Project	IEEE 802.16 Broadband Wireless Access Working Group < http://ieee802.org/16 >
Title	Terminology Change for H-ARQ MAP
Date Submitted	2004-08-24
Source(s)	Geunhwi Lim, Yong Change, Hong Sung Chang, JungWon Kim, TaeWon Kim Samsung Electronics Co. Ltd. geunhwi.lim@samsung.com
Re:	
Abstract	Terminology Change for H-ARQ MAP
Purpose	Adoption of proposed changes into P802.16d /D5-2004
Notice	This document has been prepared to assist IEEE 802.16. It is offered as a basis for discussion and is not binding on the contributing individual(s) or organization(s). The material in this document is subject to change in form and content after further study. The contributor(s) reserve(s) the right to add, amend or withdraw material contained herein.
Release	The contributor grants a free, irrevocable license to the IEEE to incorporate material contained in this contribution, and any modifications thereof, in the creation of an IEEE Standards publication; to copyright in the IEEE's name any IEEE Standards publication even though it may include portions of this contribution; and at the IEEE's sole discretion to permit others to reproduce in whole or in part the resulting IEEE Standards publicatio

Figure 23—Subchannel allocation modes of Compact DL-MAP IE for Band AMC

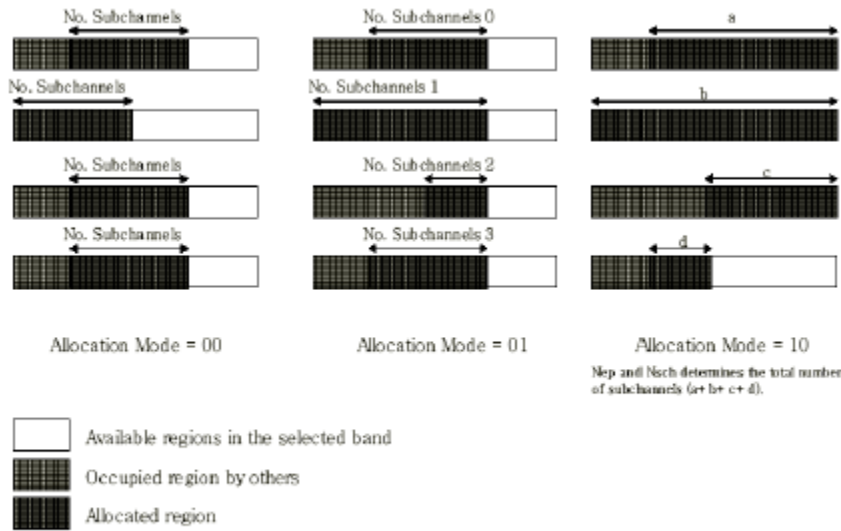
This value indicates the subchannel allocation mode in the selected bands. The value is set to binary 00 when the same numbers of [subchannels slots](#) are allocated in the selected bands by the following field '[No. Subchannels-Duration](#)'. The value is set to 01 when different numbers of [subchannels slots](#) are allocated in each selected bands by the following fields "[No. Subchannels-Duration](#)". The value is set to 10 when the total number of [subchannels slots](#) allocated in the selected bands is defined by *NSCH* code and *NEP* code. The [subchannels slots](#) fill from the bands with lowest index. The allocation mode variant is shown in Figure 23.
